<b>Model Error Resolution Document</b>  <i>Complete only applicable items.</i>		QA: QA Page 1 of 27
<b>INITIATION</b>			
1. Originator: John Case	2. Date: 06/02/2008	3. ERD No. ANL-EBS-MD-000049 ERD 02

4. Document Identifier: ANL-EBS-MD-000049 REV 03 AD 02		5. Document Title: Multiscale Thermohydrologic Model	
6. Description of and Justification for Change (Identify applicable CRs and TBVs):  Editorial corrections and clarifications to ANL-EBS-MD-000049 REV 03 AD 02 are made in response to CR-11935. In addition, deficiencies in data qualification as identified in CR-11936 are addressed. A justification for no impact to results of the subject report, and for other products that use output from this report as direct input, is also included.  See attached pages for details.			
<b>CONCURRENCE</b>			
	Printed Name	Signature	Date

Condition Report (CR) 11935 documents a set of issues related to ANL-EBS-MD-000049 REV 03 AD 02 (SNL 2008 [DIRS 184433]), which were found during Lead Lab QA surveillance LQA-IS-08-002. This document presents the disposition of those issues, identifying changes to the analysis/model report (AMR), and evaluating the impact of those changes on the conclusions of

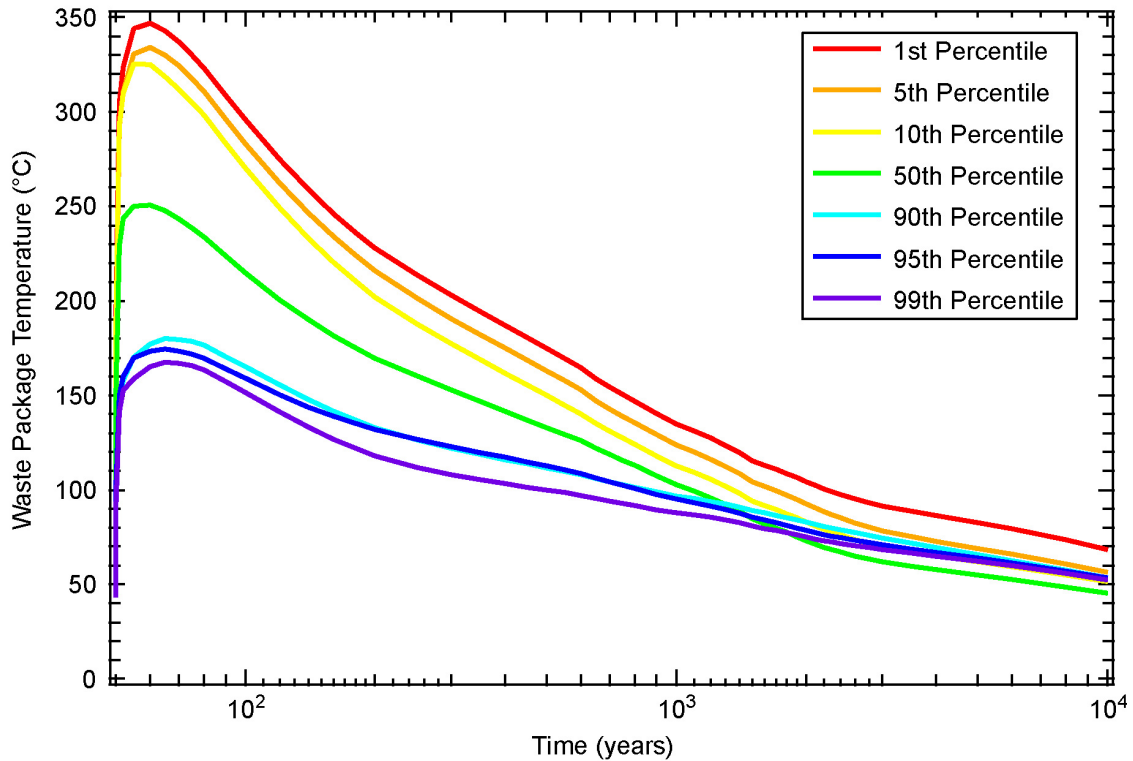
- II.35** (Issue 108 from surveillance; p. X-11[a]): *Section X.4[a]. Unsaturated...Invert. Line 2 of the paragraph mentions  $K_{us}$ . This is probably  $K_{ul}$  for which Eq. X-27 [a] defines a formula.*

**AMR Change:**

Appendix X[a], change all references to  $K_{ul}$  to read  $K_{us}$ .

The text for the presentation of the relative permeability relationship presented on p. X-11[a] is revised to read:

The relative permeability relationship is given by Fetter (1993 [DIRS 102009], p. 182, Equation 4.17) based upon the van Genuchten parameters and the conversion to hydraulic conductivity:
